**MT. SAN JACINTO COMMUNITY COLLEGE DISTRICT**  
**ADDENDUM NO. 2**  
**BID NO. 2019-016**  
**GEOTECHNICAL ENGINEERING CONSULTING SERVICES FOR**  
**5000 SEAT STADIUM AND BUILDINGS AT**  
**MENIFEE VALLEY CAMPUS**

February 25, 2019

**BOUNDARY, TOPO, AND UTILITY DRAW**  
**MT. SAN JACINTO COLLEGE**  
28237 La Piedra Rd.  
Menifee CA 92584

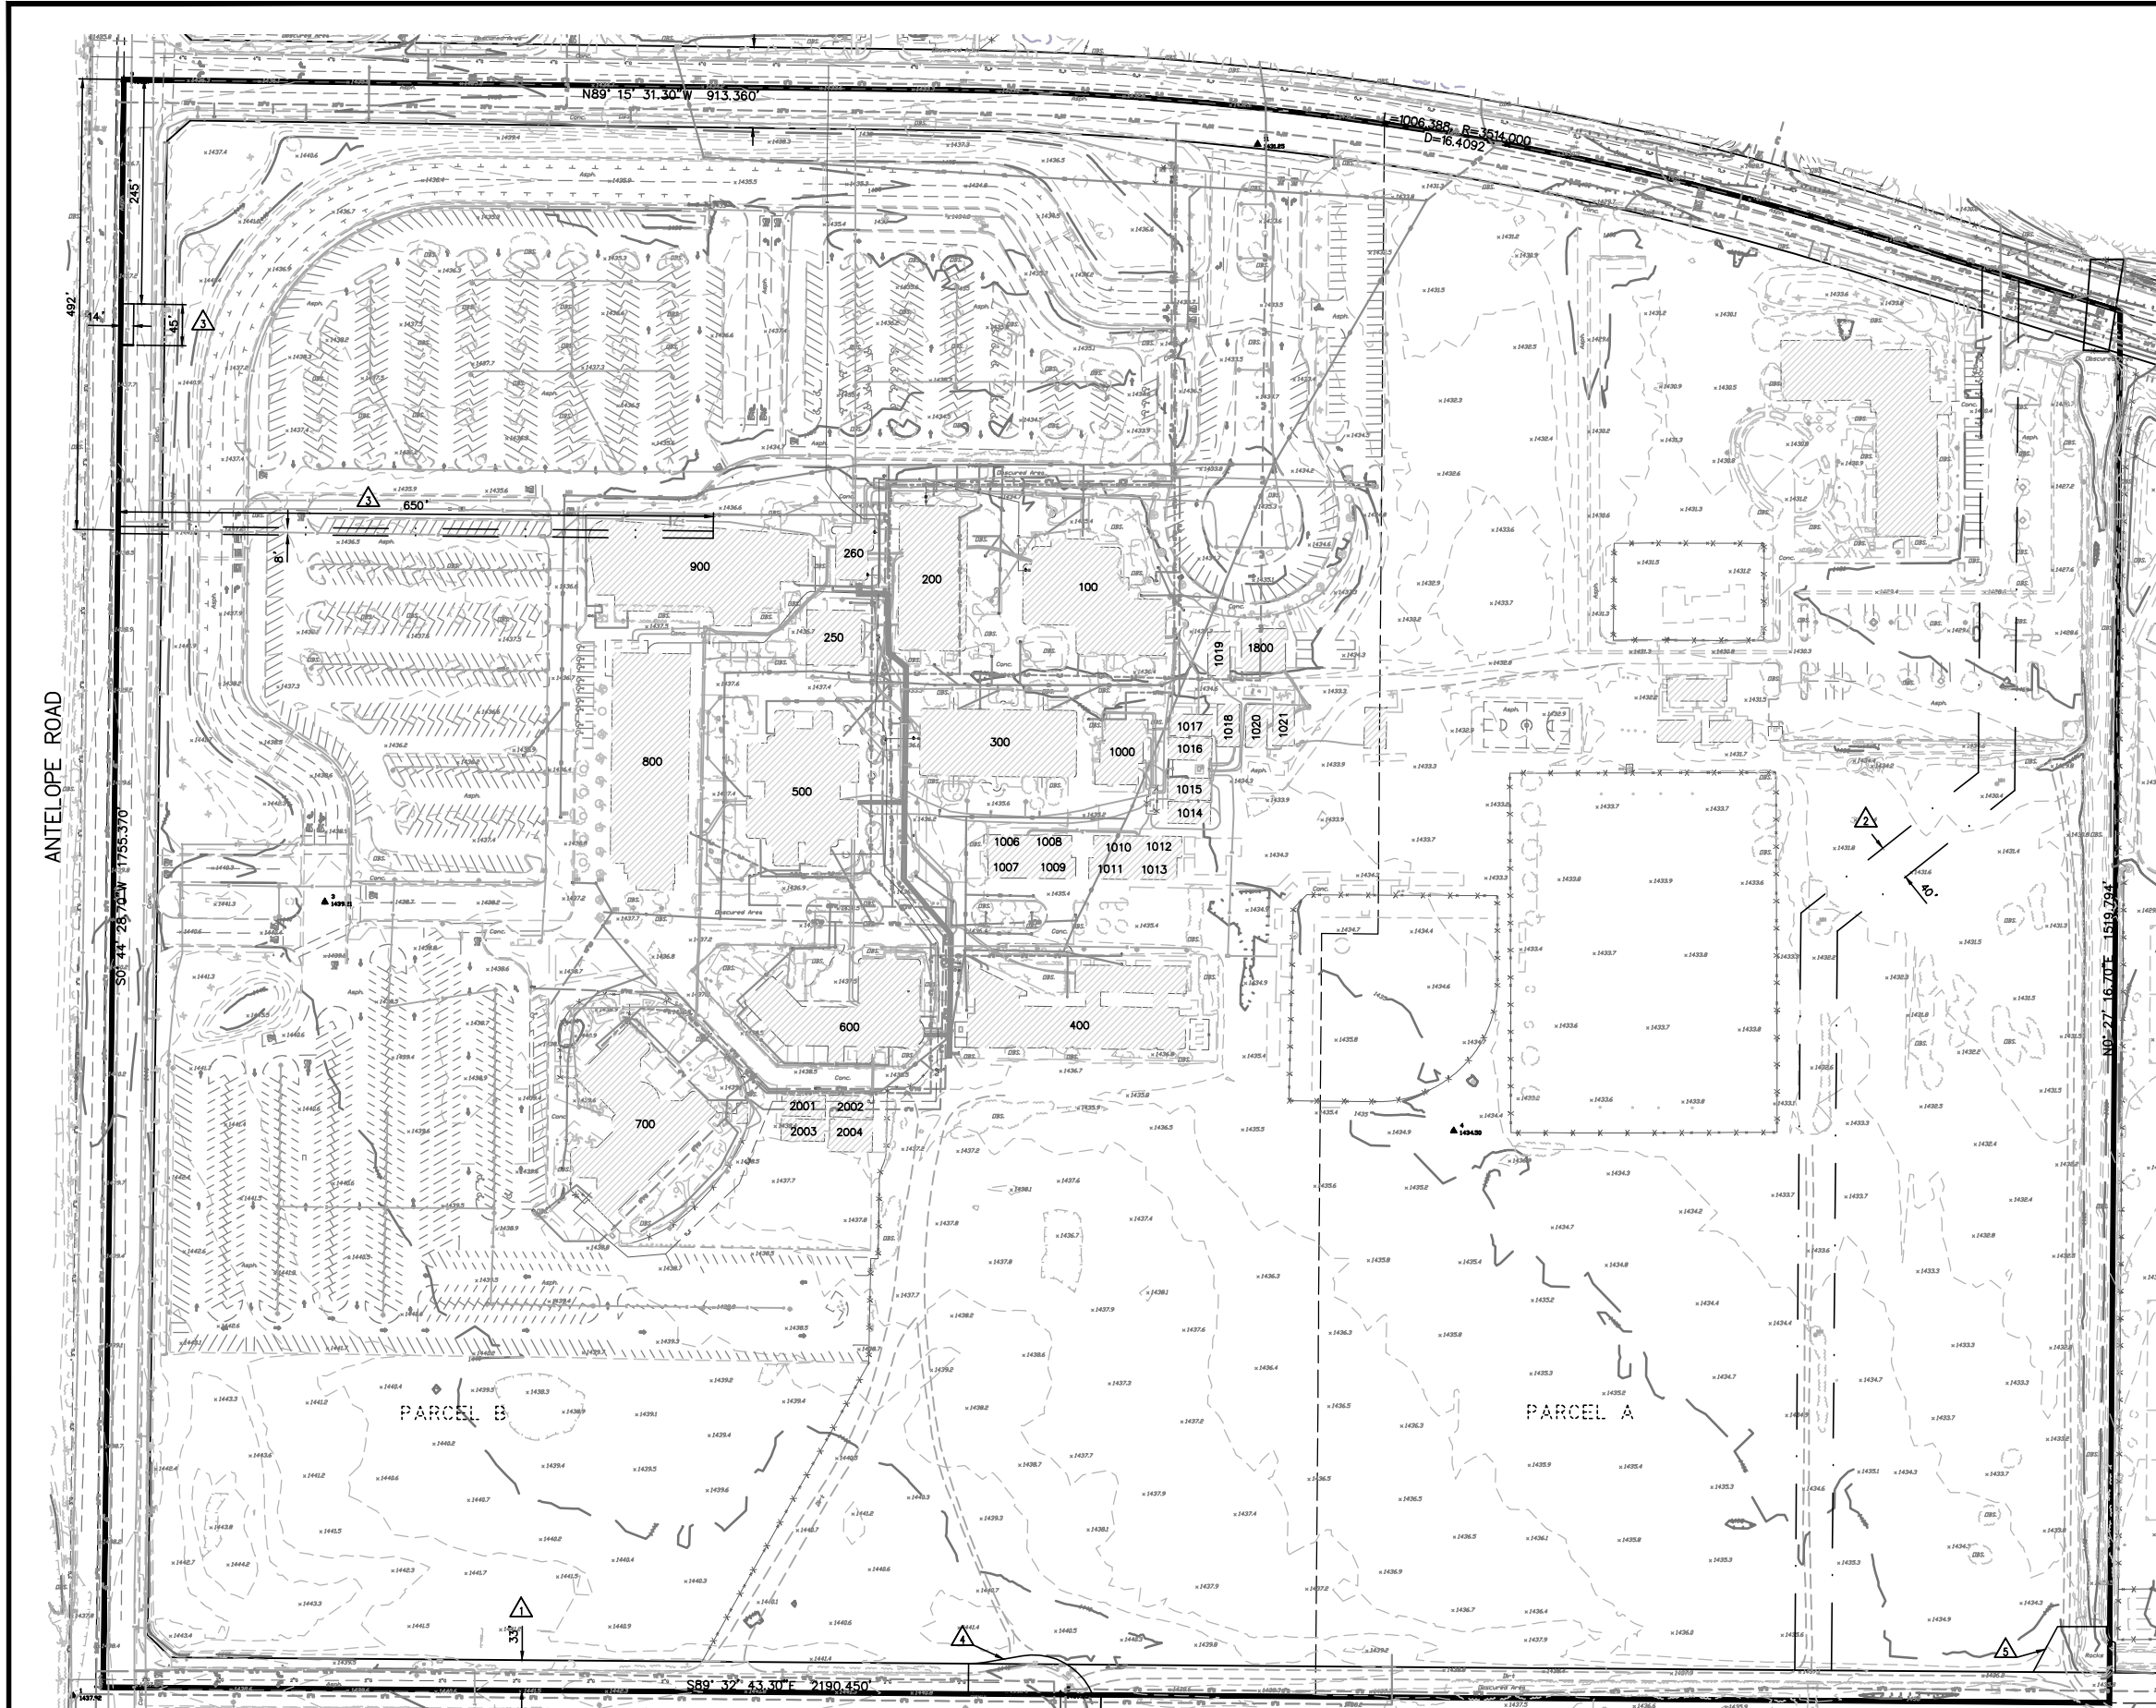
The new stadium facility, support building with parking lot will be placed in this area.
